AUTOMATIC TRANSMISSION SERVICE GROUP

"VOLUME II"

INTRODUCTION

Since the introduction of the THM 440-T4 (4T60) Transaxle in April, 1984, there have been MANY major engineering design changes. These changes have affected nearly every part used in the THM 440-T4 (4T60).

Figure 15

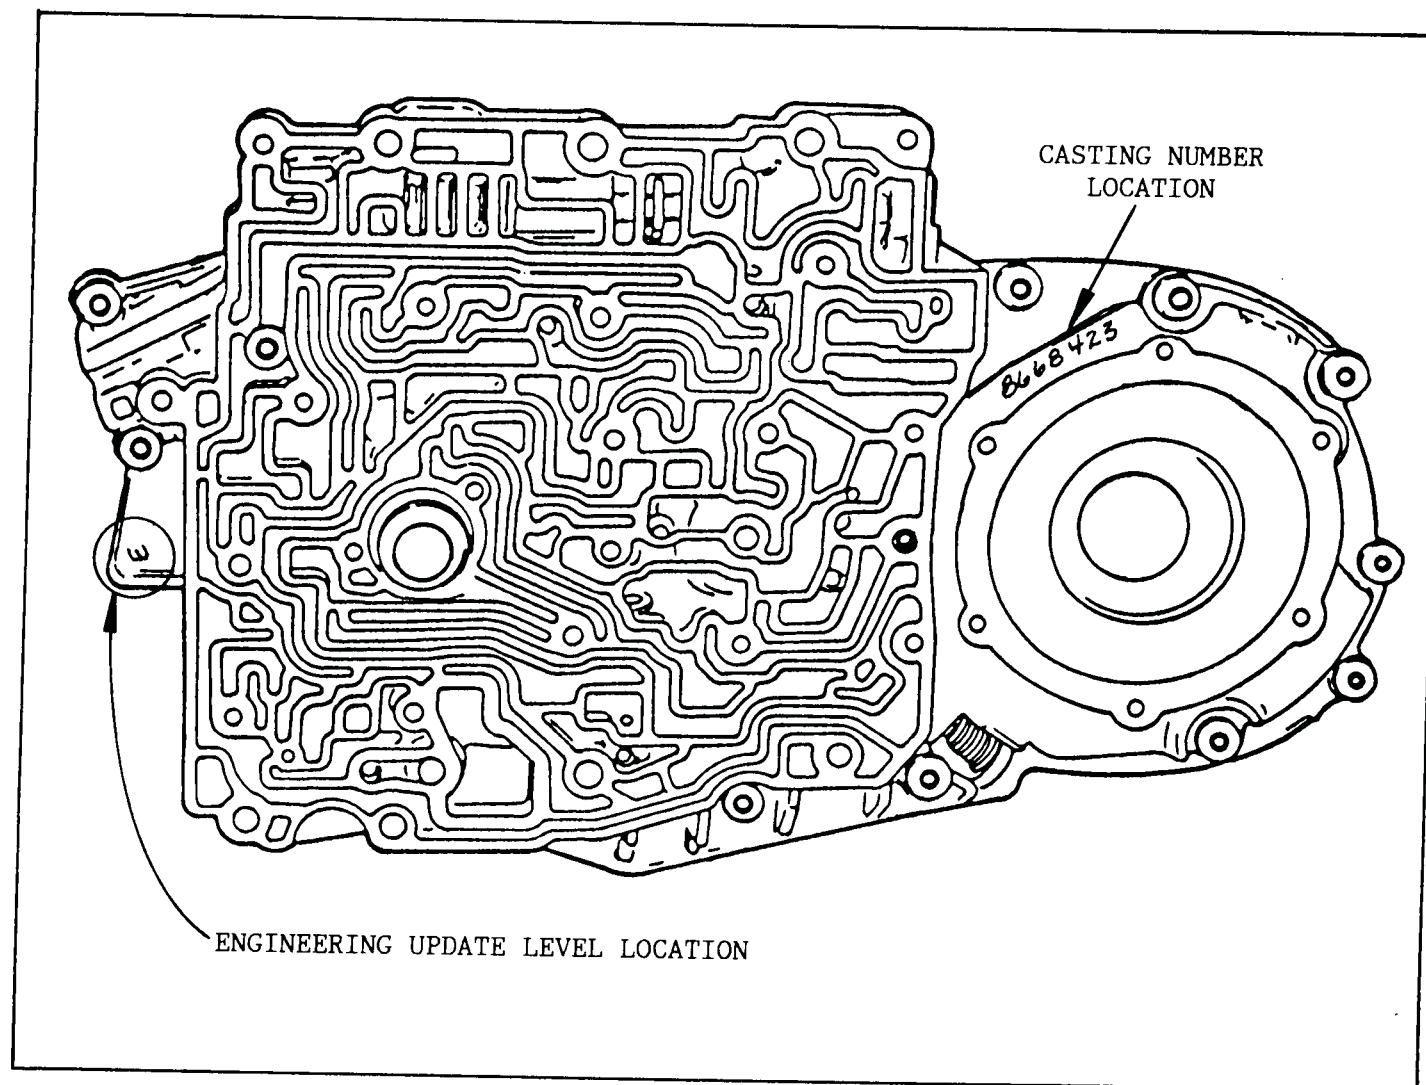
This was created by a change in the channel plate porting, in the manual valve area. The questionable channel plate can be identified by the casting number "8668423", with engineering update level "E". Refer to Figure 15 for locations. Casting number "8668423" with engineering update levels "A", "B", "C", and "D" are OK to use.

DO NOT USE CASTING NO. "8668423" WITH ENGINEERING UPDATE LEVEL OF "E" OR HIGHER - REFER TO FIGURE 15 FOR LOCATIONS.

CORRECTION: Install an earlier model channel plate that does not have the questionable casting number 8668423.

Figure 16

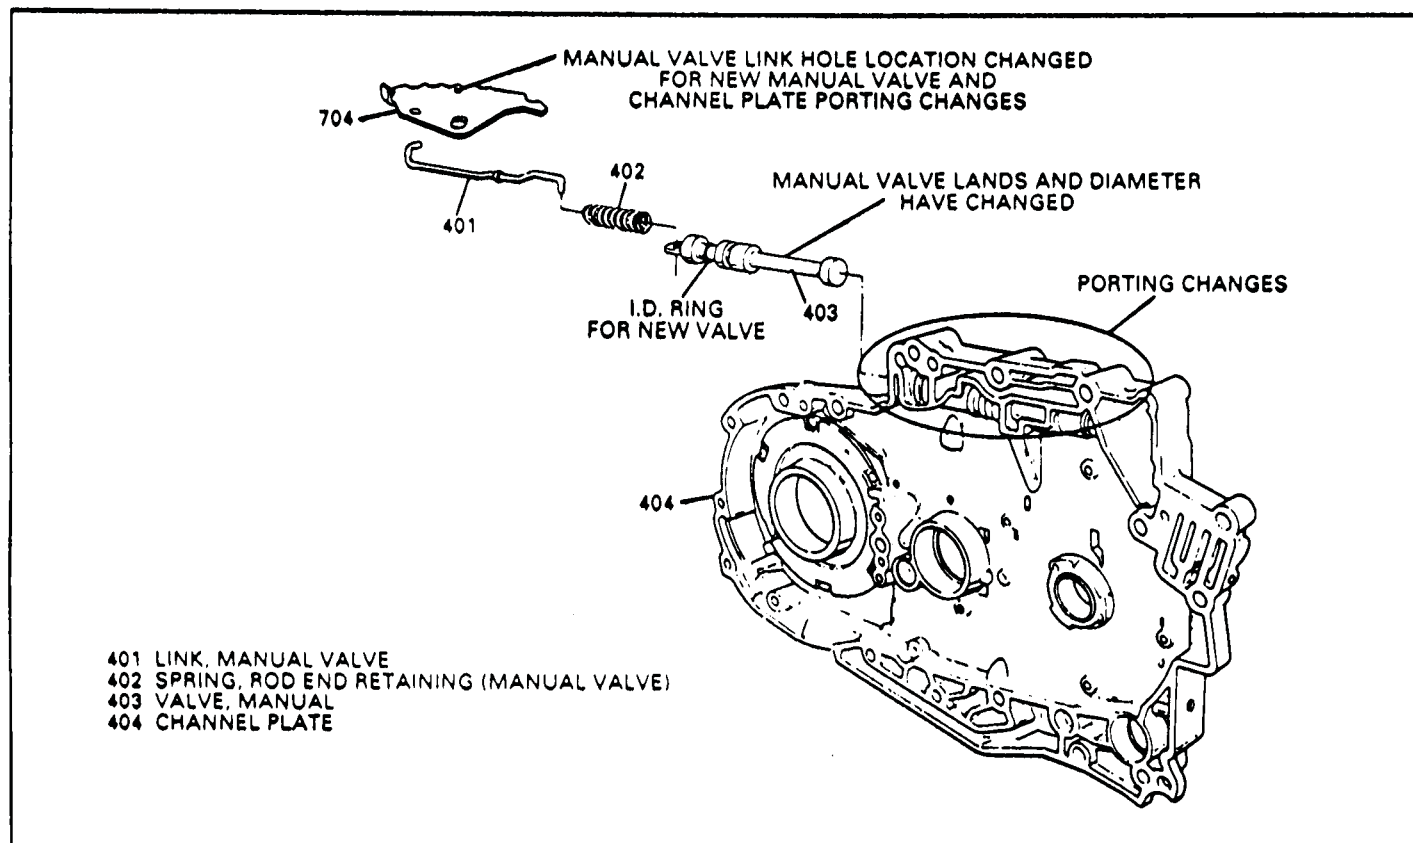
NEW CHANNEL PLATE - Will have porting changes for the new manual valve and new inside detent lever. The porting changes will help ensure that two ports will never be opened at once to cause burnt 4th clutch assembly. The bore for the new manual valve has been reduced by .010" to accommodate the new manual valve. This will make the previous and new parts non-interchangeable (See Figure 16).

Figure 17

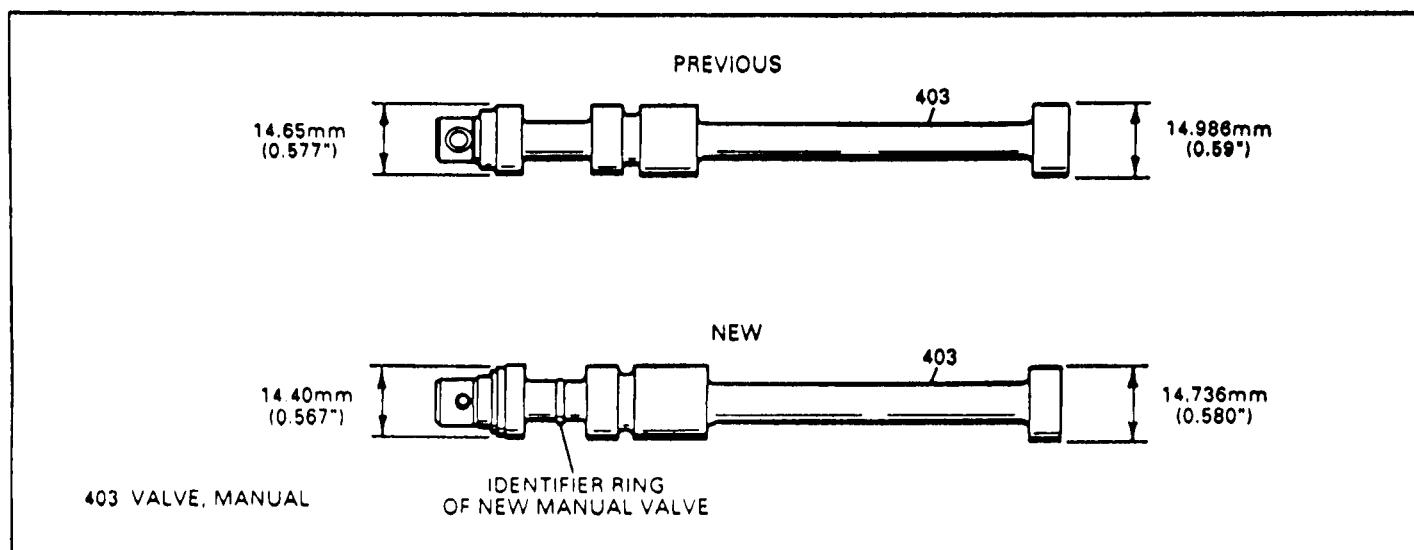
NEW MANUAL VALVE - Will have changes to the valve lands and reduced .010" in diameter to make it compatible with the new channel plate. The previous and new manual valve are not interchangeable. The new manual valve can be identified by a ring between the first two lands as shown in Figure 17.

Figure 18

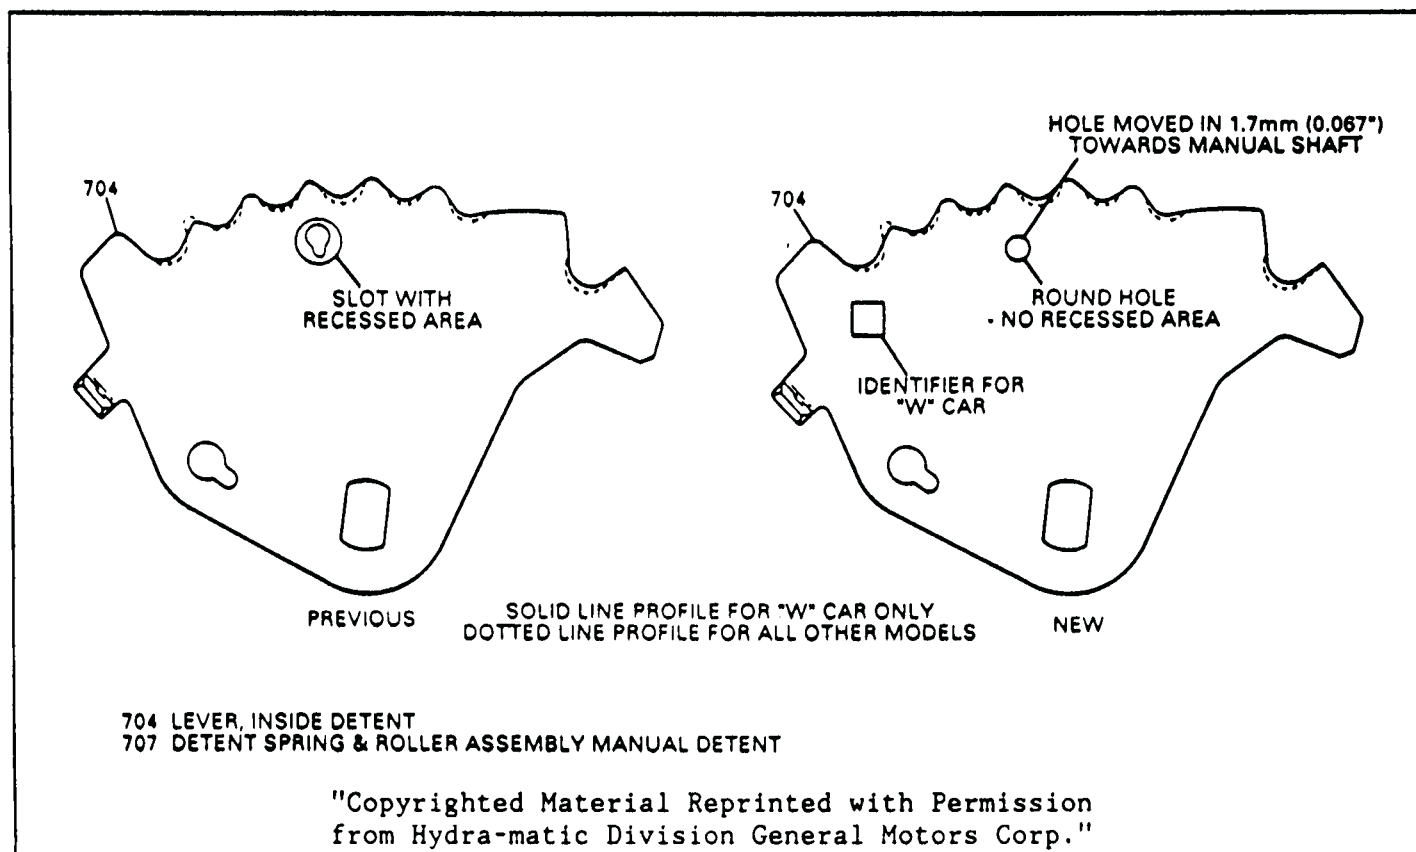
NEW INSIDE DETENT LEVER - Will have the manual link hole location changed to provide a different "Throw" of the manual valve, and the hole is now round instead of "Key Hole" shaped. Since the "W" car detent lever is different than all others, it will have a square identification hole punched in it. The previous and new inside detent levers will not interchange. See Figure 18 for identification.

Figure 19

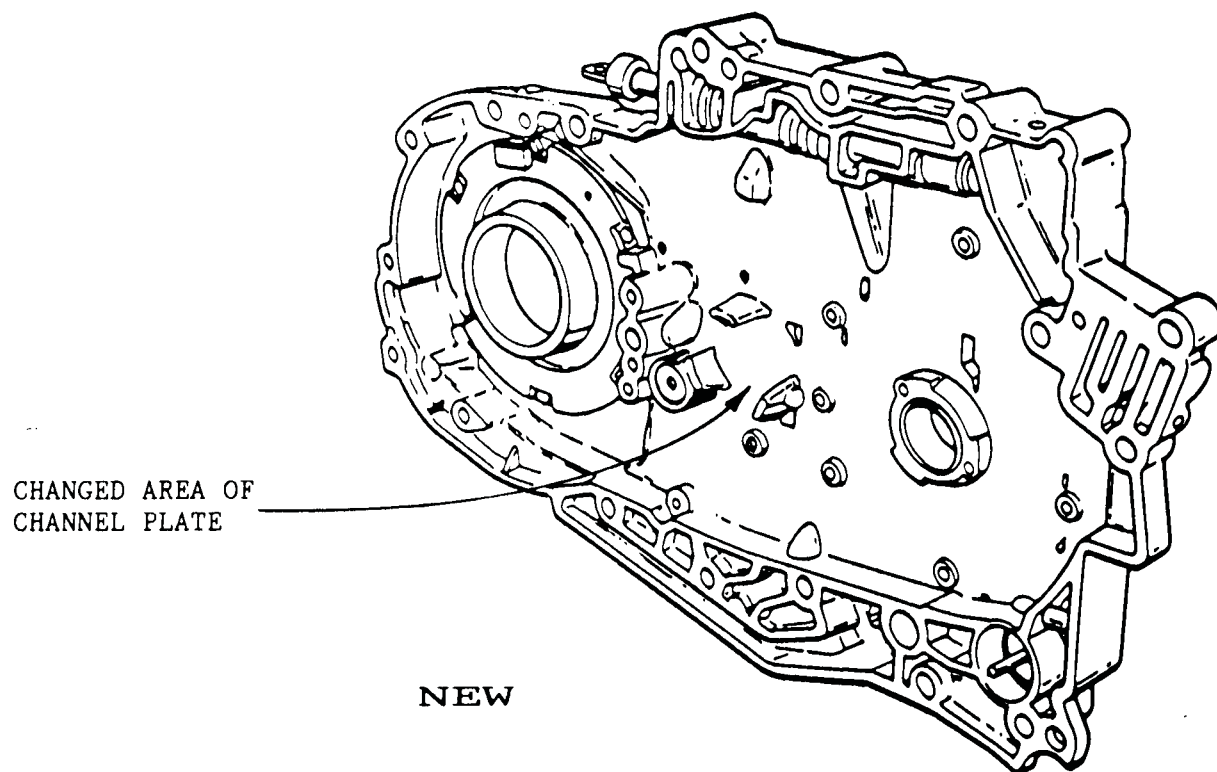
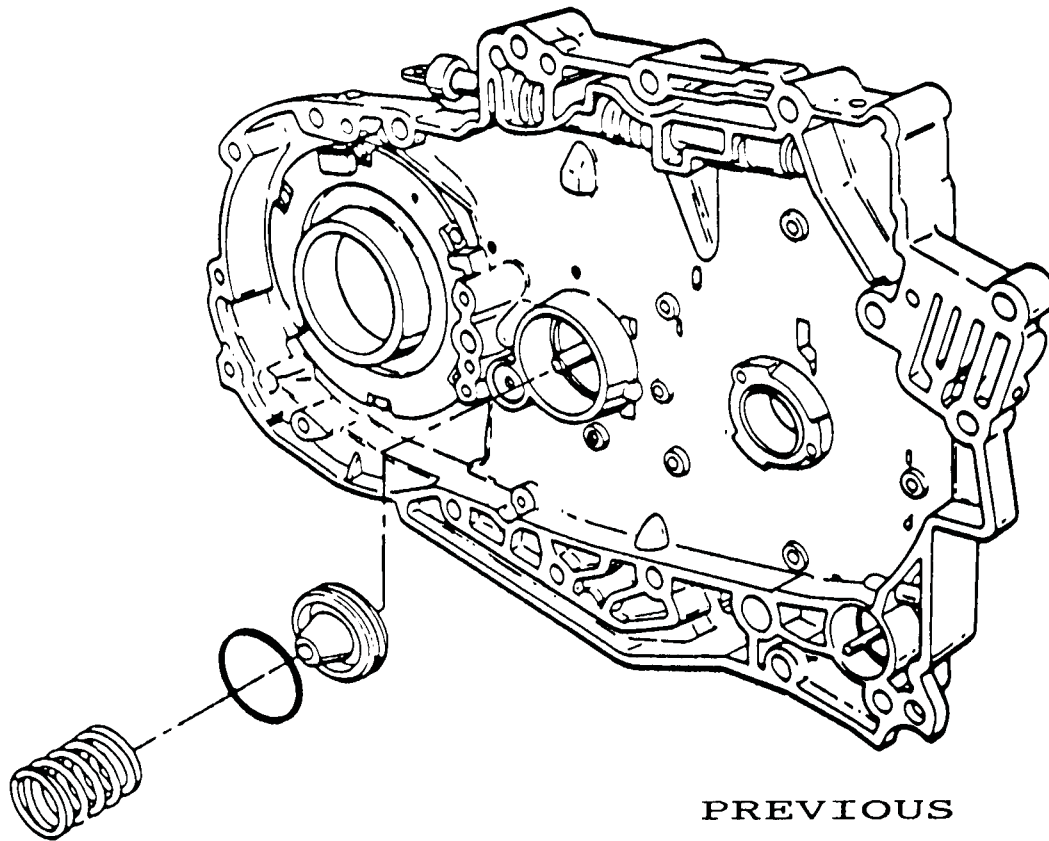
CHANGE: The Input Clutch Accumulator has been eliminated from the channel plate (See Figure 19).

- (1) CHANNEL PLATE - The input clutch accumulator piston, piston pin, and accumulator spring have been eliminated from the channel plate, which of course changes the channel plate casting (See Figure 19).
- (2) INPUT HOUSING - Top snap ring groove moves .060" closer to the top of the input housing, to accomodate the added wave plate (See Figure 20).
- (3) INPUT CLUTCH STEEL PLATES - The steel plates are .027" thinner to help accomodate the added wave plate (See Figure 21). The new steel plates are .049" thick, and the old steel plates are .076" thick (Figure 21).
- (4) INPUT CLUTCH "STACK-UP" - The input clutch stack has also been revised to accomodate the new changes. Refer to Figure 21 for proper assembly of the new input clutches.

Figure 22

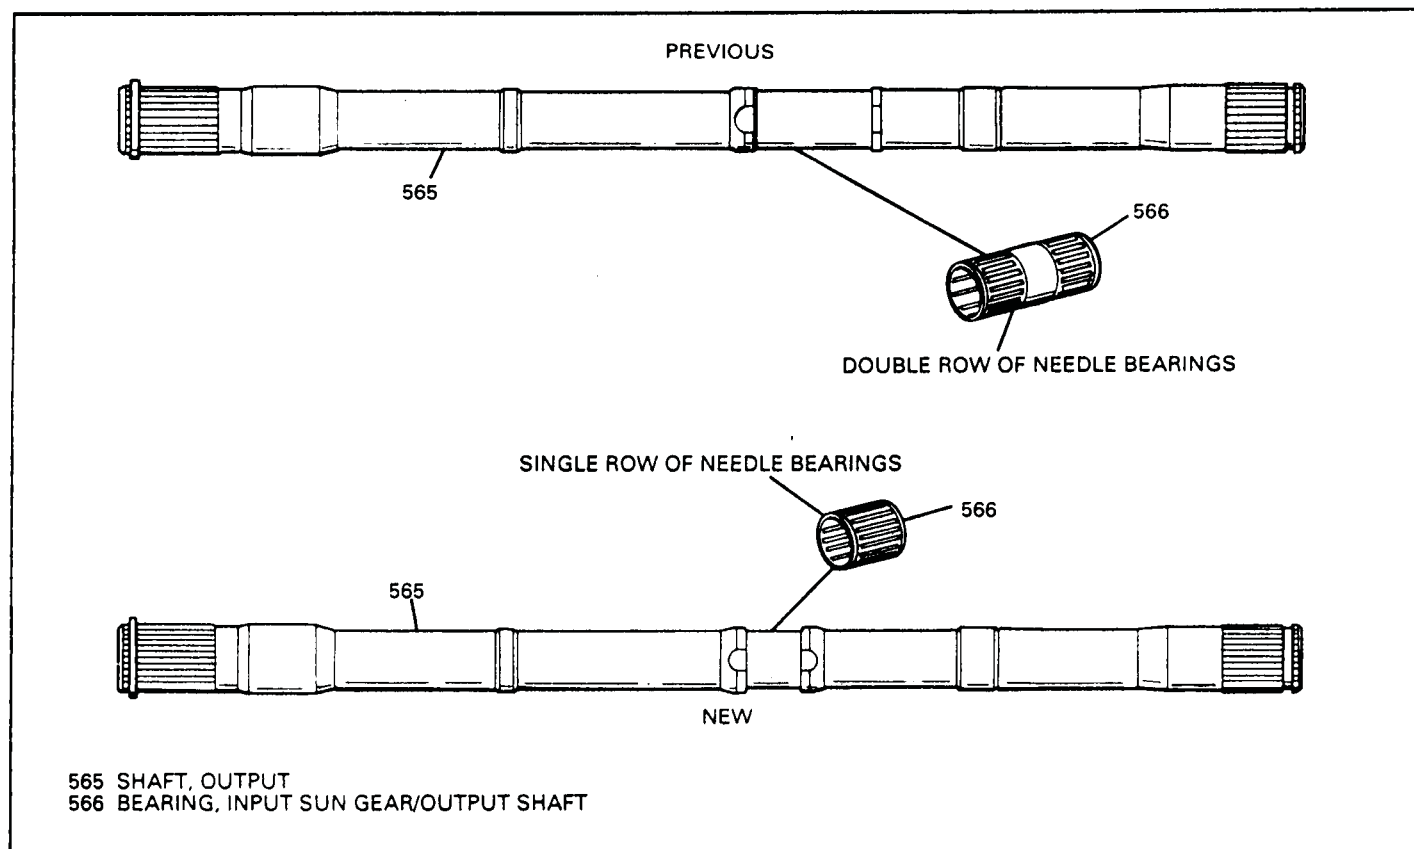
CHANGE: There is now a new Output Shaft/Bearing Assembly, and a new style (5th Design) 3rd Roller Clutch Assembly (See Figures 22 and 23). Beginning on December 11, 1989 (Julian Date 345) all 1990 model 440-T4 transaxles were built with the new 3rd Roller Clutch Assembly, and the new Output Shaft/Bearing Assembly went into production on January 25, 1990 (Julian Date 025).

- (1) OUTPUT SHAFT/BEARING - The new bearing has a single row of needle bearings instead of a double row, and the output shaft is machined different to accomodate the new bearing (See Figure 22). This change will improve lube oil flow to the 3rd roller clutch and input sprag.
- (2) 3RD ROLLER CLUTCH ASSEMBLY - The new 3rd roller clutch outer race has four (4) less lube holes than previous models. The four lube oil holes are in line with the very end of the rollers (See Figure 23). Elimination of these four holes helps keep the rollers from "Skewing" (Running at an Angle), thus generating less heat.

Figure 26
AUTOMATIC TRANSMISSION SERVICE GROUP

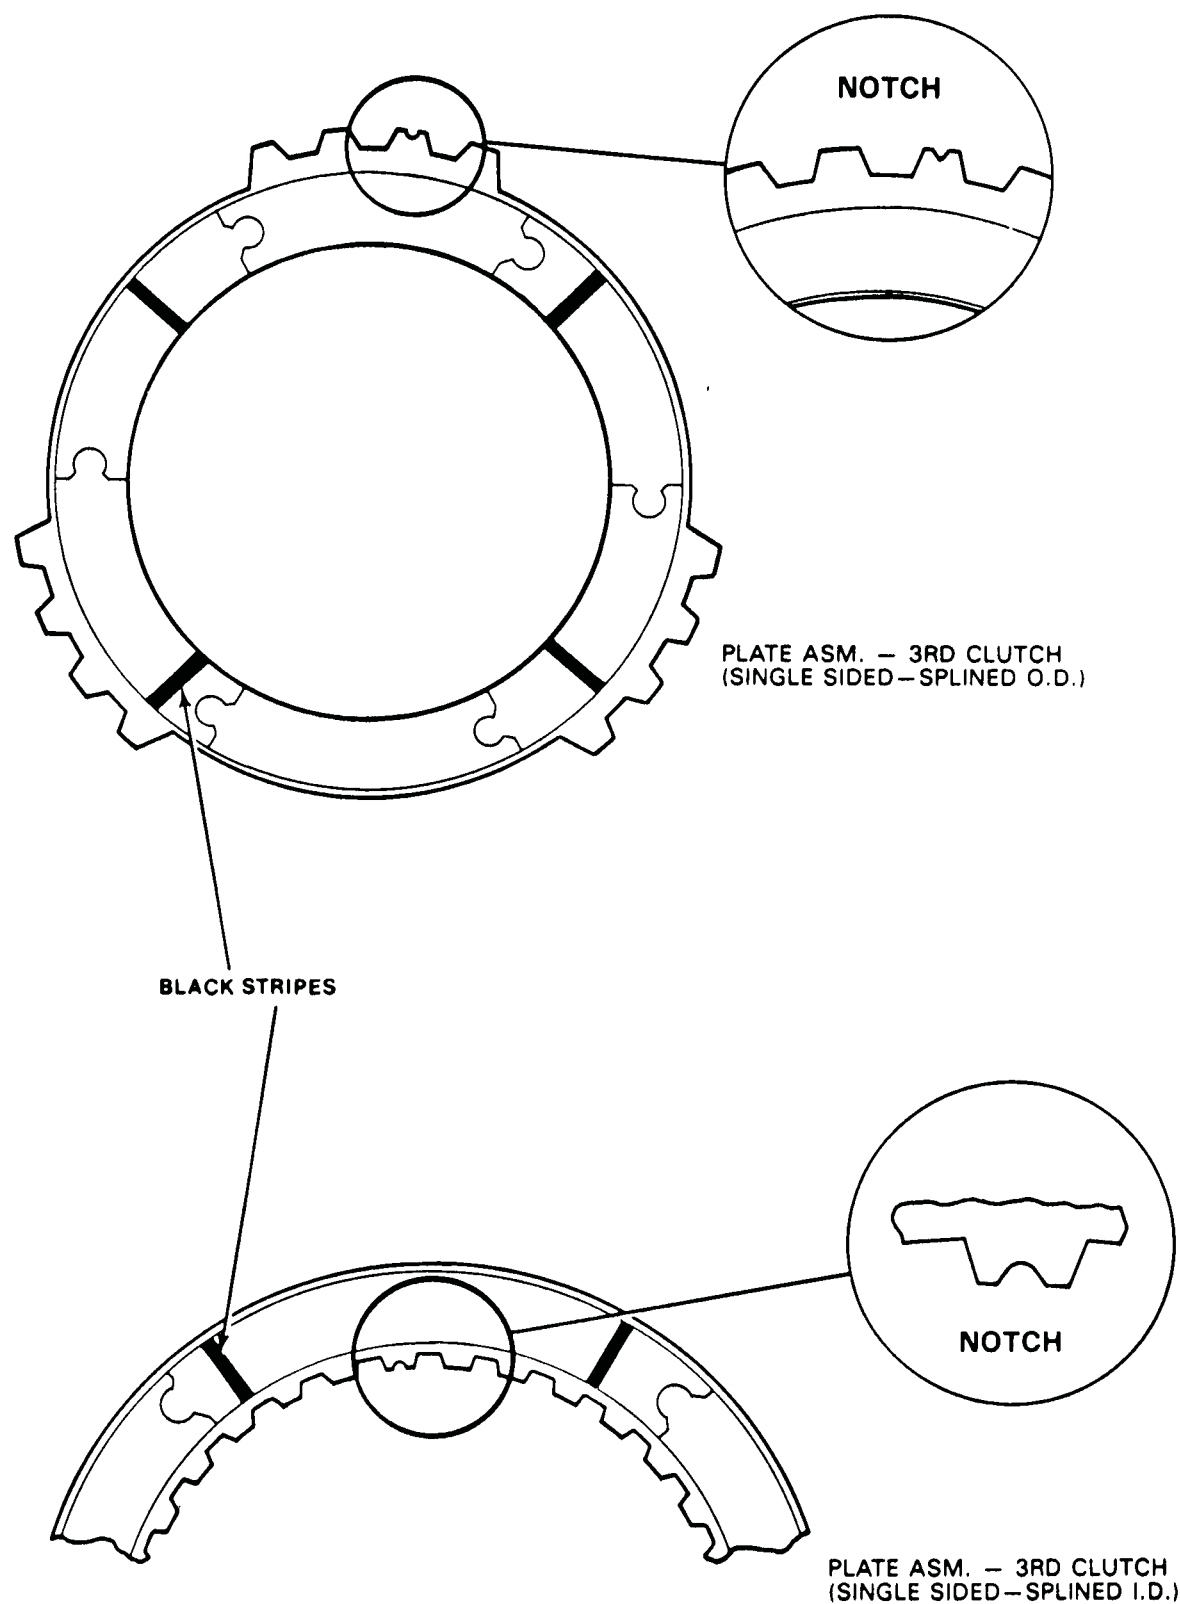
- (1) 3RD CLUTCH PLATES - Change of Fiber Material on the 3rd clutch plates, and can be identified by four (4) black stripes and/or "Notch" cut in one of the teeth, and/or NO identification at all (See Figure 26).
- (2) NEW MODEL CODES - Were assigned when the fiber material change on the 3rd clutch plates was put into production (See Figure 27).
- (3) SPACER PLATE - Was changed on some models. To identify the new spacer plate, see Figure 28 for numbers.
- (4) VALVE BODY CALIBRATION - Goes as follows: (Refer to Figure 29)
 - A. 2-3 accumulator valve spring (Most Models).
 - B. 3-2 control valve spring (All Models).
 - C. 1-2 accumulator valve spring (CPH Models Only).
